THRUSH AIRCRAFT, LLC.

SERVICE BULLETIN

No. SB-AG-45

FIN SPAR & ATTACH FITTINGS INSPECTION AND UPGRADE

Figure 45-1: Location of Attach Fittings

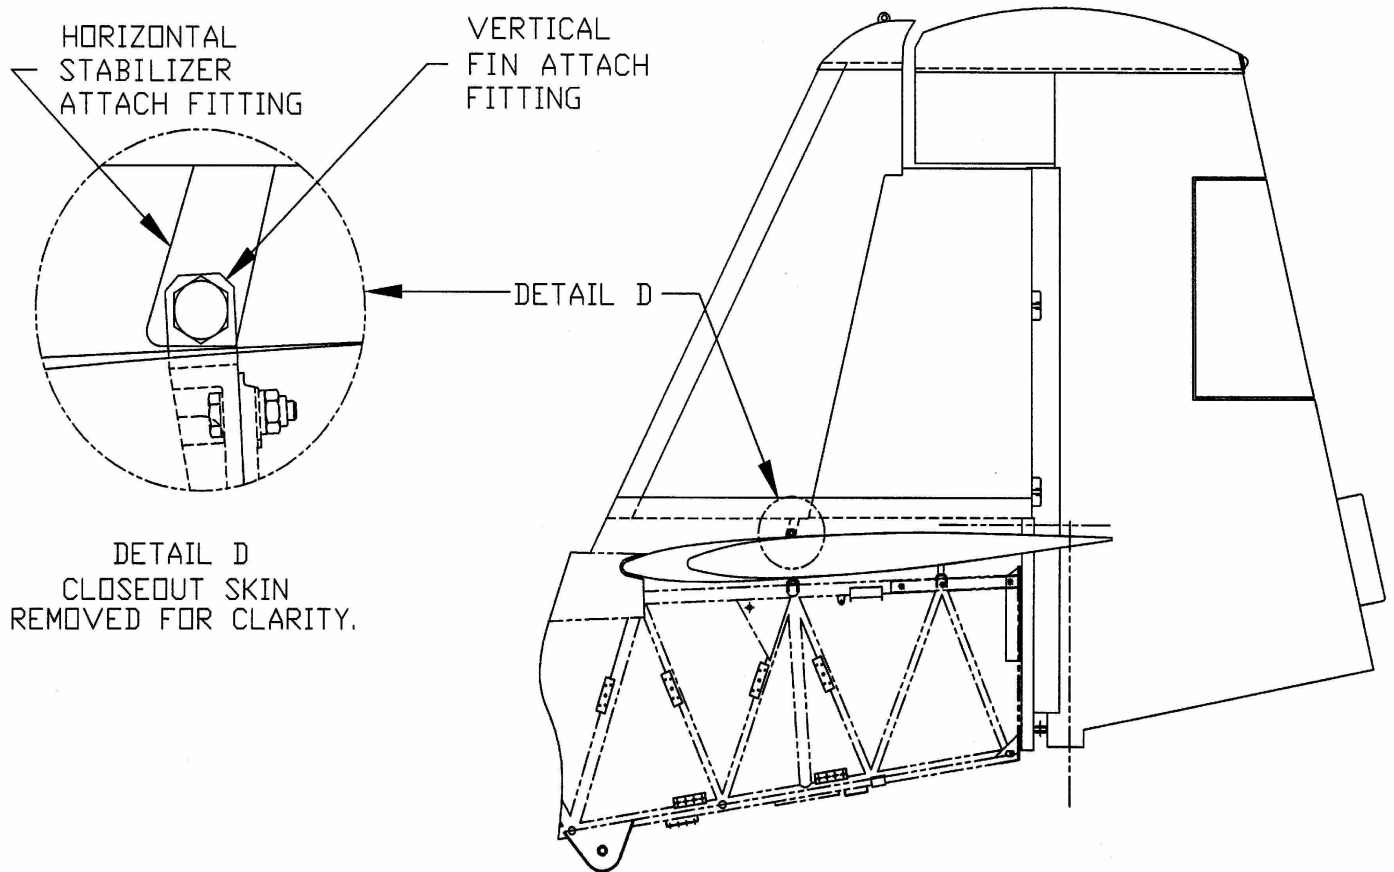
The vertical stabilizer attach fitting, horizontal stabilizer attach fitting and bolt must be re-inspected every 100 hours thereafter until they are replaced with the 95266-11 vertical fin attach fitting, 95267-5 horizontal stabilizer attach fitting, and larger bolt per SB-AG-45 Rev. D. See Figure 45-1 for the location of these fittings and bolt.

Figure 45-2: Inspect Vertical Fin Spar Assy., Using a 10X magnifier at the Upper Attach Bolts

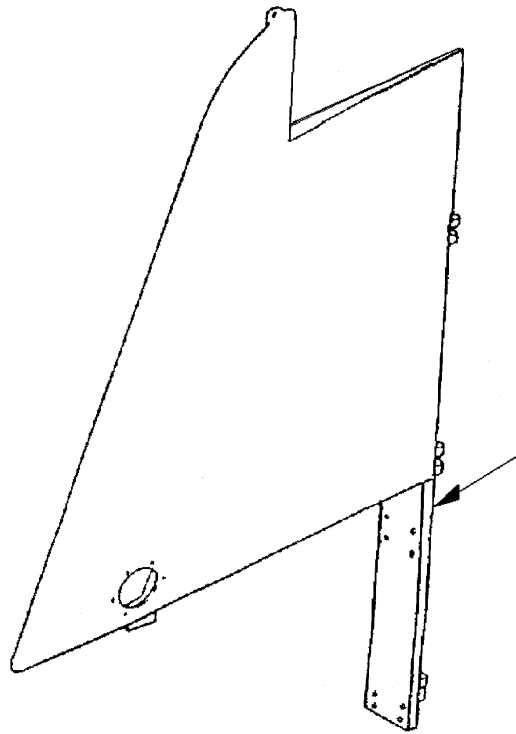
Remove the rudder from the aircraft. Remove vertical fin fairings, dorsal fin if installed, and the top four bolts attaching the aft vertical stabilizer spar to the fuselage frame. Loosen the bottom four bolts attaching the aft vertical stabilizer spar to the fuselage. While in this area, carefully inspect the vertical fin aft spar for cracks, using a 10X magnifier; especially in the area between the top attach bolts and the center rudder hinge (Ref. Fig. 45-2). Repair, replace and/or refinish the aft spar as necessary.

Figure 45-3: Areas of vertical fin attach fitting to be inspected for cracks

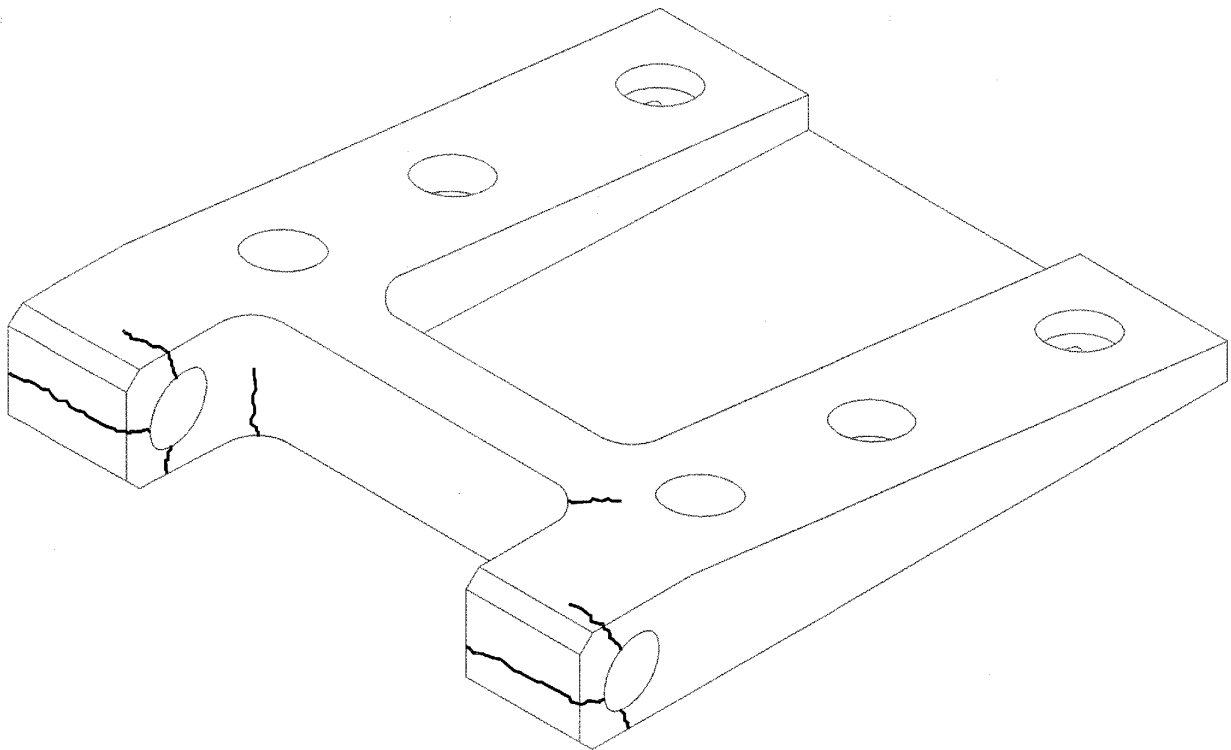
Remove the bolt holding the horizontal stabilizer attach fitting to the vertical fin attach fitting on the horizontal stabilizer. **(This terminology may be confusing. The vertical fin attach fitting is on the horizontal stabilizer, and the horizontal stabilizer attach fitting is on the vertical fin.)** Tilt the vertical fin aft until the inner faces of the horizontal stabilizer attach fitting lugs are easily visible. Block the vertical fin in this position with wood blocks. Using a 10X magnifier, visually inspect both lugs of the vertical fin attach fitting on the horizontal stabilizer and the rest of its exposed surfaces for cracks. If the paint is cracked, discolored or bubbled, remove loose paint prior to inspection, as this can hide cracks or corrosion. Also inspect the inside of the holes as much as possible. See Figure 45-3 for areas most suspect for cracks.

Figure 45-4: Use of Hole Transfer Fixture ESK 708-14/15 for Stabilizer Attach Fitting

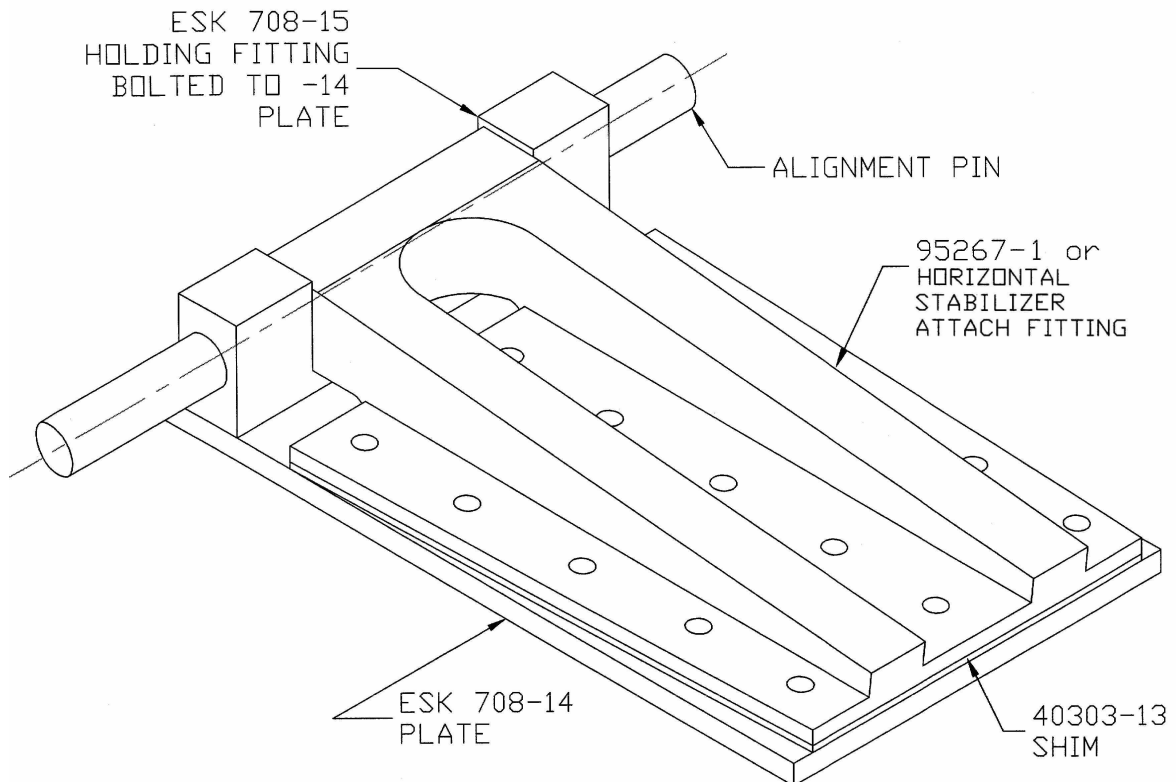
5. Install old horizontal stabilizer attach fitting, removed from the vertical fin, on the -14/15 holding fixture using a 6" 5/16" (7/16" if SB-AG-45 has been complied with) pin or drill shank for alignment (see Fig. 45-4). Using a suitable "C" clamp, clamp the fitting to the plate. If the old fitting is a steel weldment, drill #30 through the 15 holes (3 rows of 5 ea.) nearest to the tube at the top of the steel fitting, using the old steel fitting as a drill jig. Do not drill the large holes in the steel attach fitting. Remove the old steel fitting and discard it. If the old fitting is aluminum, a .10" shim must be between the fitting and the -14 plate before clamping. If the old shim is used for this, ensure the holes are either aligned with the fitting or totally out of line, so as not to cause the drill to wander. Drill all of the aluminum fitting's holes #30 into the ESK 708-14 plate. Remove the old aluminum fitting and shim and discard them. Deburr the ESK708-14 plate and remove the ESK 708-18 bushings from the -15 holding fitting (if used).

6. Install the new P/N 95267-5 horizontal stabilizer attach fitting onto the -14/15 holding fixture just drilled using a 7/16" alignment pin or 6" 7/16" drill shank (see Fig. 45-4). The new 40303-13 shim installs between the fitting and the plate. Using "C" clamps, clamp the new aluminum horizontal stabilizer attach fitting and shim to the -14 plate.

Figure 45-5: Use of Hole Transfer Fixture for Vertical Fin Fitting

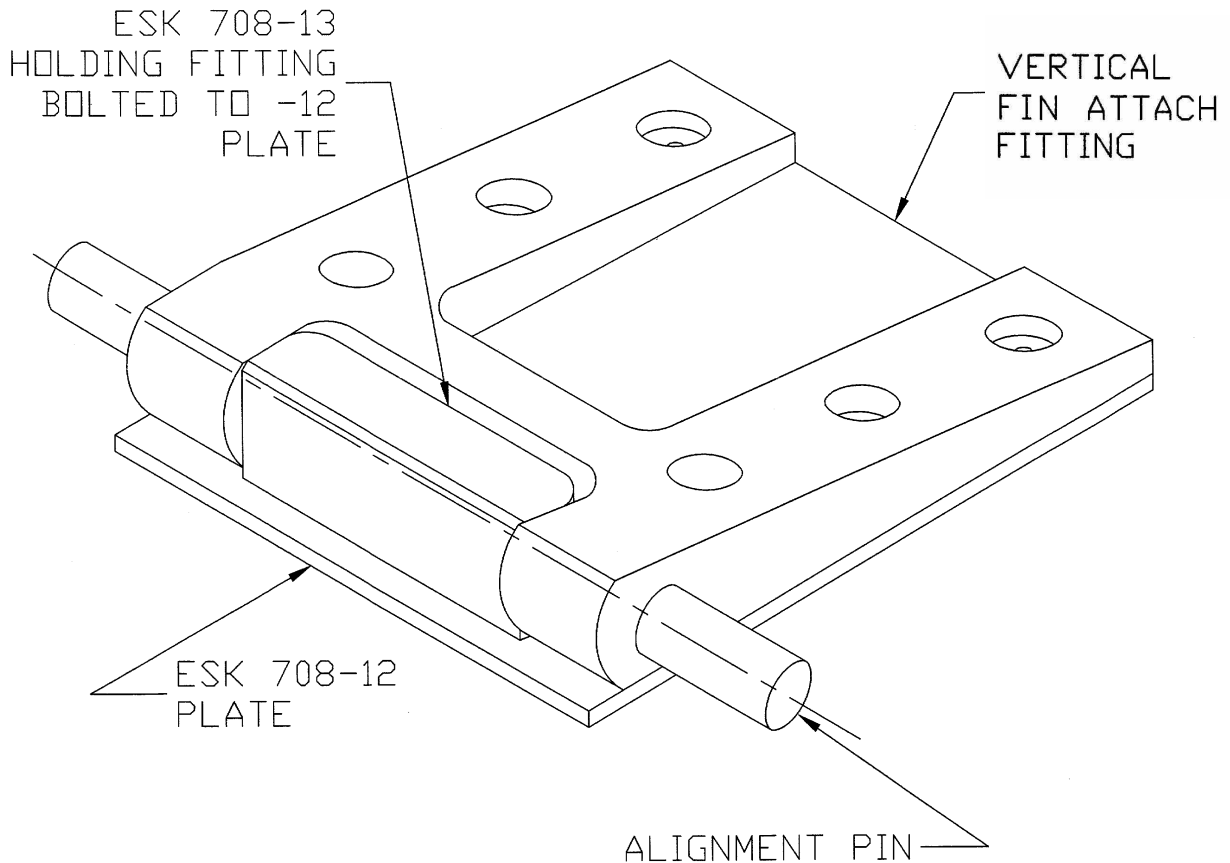
7. Through the bottom access holes in the horizontal stabilizer, remove the existing vertical fin attach fitting. Inspect the horizontal stabilizer forward spar for condition and corrosion and repair and/or refinish as necessary. Note any holes that need to be enlarged for clean-up. Corresponding holes in the new fitting must be enlarged after the holes have been drilled per step 8.
8. The hole pattern of the old vertical fin attach fitting must be transferred to the new 95266-11 vertical fin attach fitting. The #11 holes have been left out of the 95266-11 for this purpose. Tool ESK708-12/13 serves to ensure that the hole pattern in 95266-11 matches the hole pattern in the horizontal stabilizer spar. See Figure 45-5 for use of this tool.

The ESK 708-13 holding fitting is attached to the ESK 708-12 plate with two NAS 1203-2 bolts. Install an ESK 708-17 bushing in the -13 holding fitting if SB-AG-45, installing a 7/16" bolt, has not been complied with. The vertical fin attach fitting previously removed is attached to the ESK 708-13 fitting with a 5/16" pin or drill shank. Once installed on the -13 fitting, clamp the old vertical fin attach fitting to the -12 plate. Drill six #11 holes in the -12 plate using the old vertical fin attach fitting as a drill template. Remove the old vertical fin attach fitting and discard it. Deburr the -12 plate and remove the ESK 708-17 bushings. Install the new 95266-11 fitting on the -12/13 holding fixture using a 7/16" pin or drill bit shank and C-clamps. Turn this assembly over and back-drill the 95266-11 fitting #11 six places using the -12 plate as a drill template. Remove the 95266-11 fitting and deburr the holes. Discard the ESK 708-12 plate. The ESK 708-13 holding fitting may be used for another airplane by locally fabricating a new ESK 708-12 plate (see Fig. 45-6).

Figure 45-6: Hole Pattern Transfer Plates. Material .100-.188 Aluminum

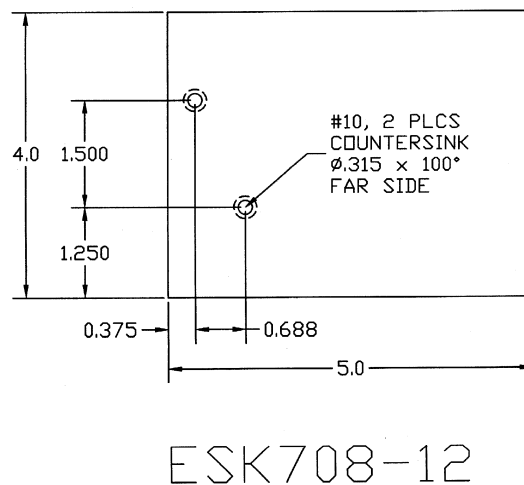
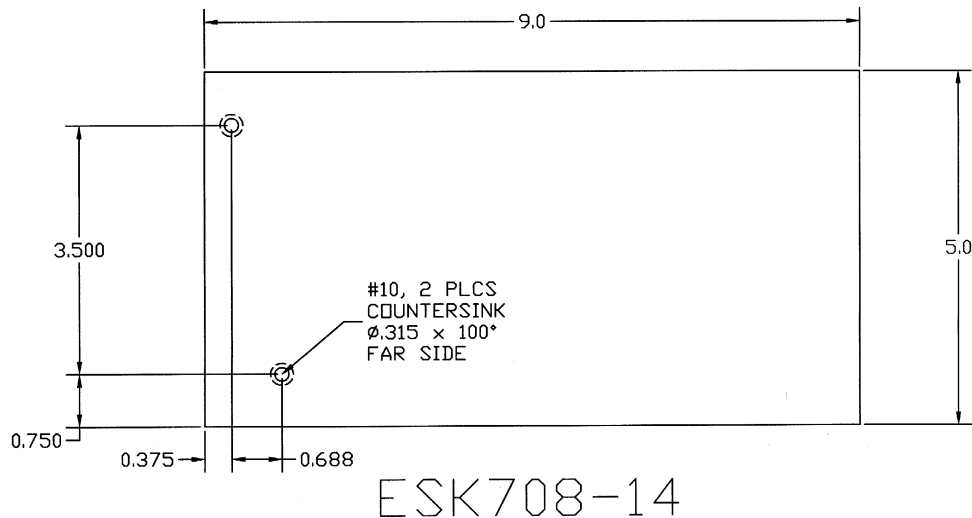
Invert this assembly and back drill the #30 holes through the new aluminum fitting and shim, using the -14 plate as a drill template. Remove the aluminum fitting and shim from the fixture and discard the -14 plate. Deburr new aluminum fitting and shim. Note that the -15 holding fitting may be used to do another airplane by locally fabricating a new -14 plate (see Fig. 45-6).
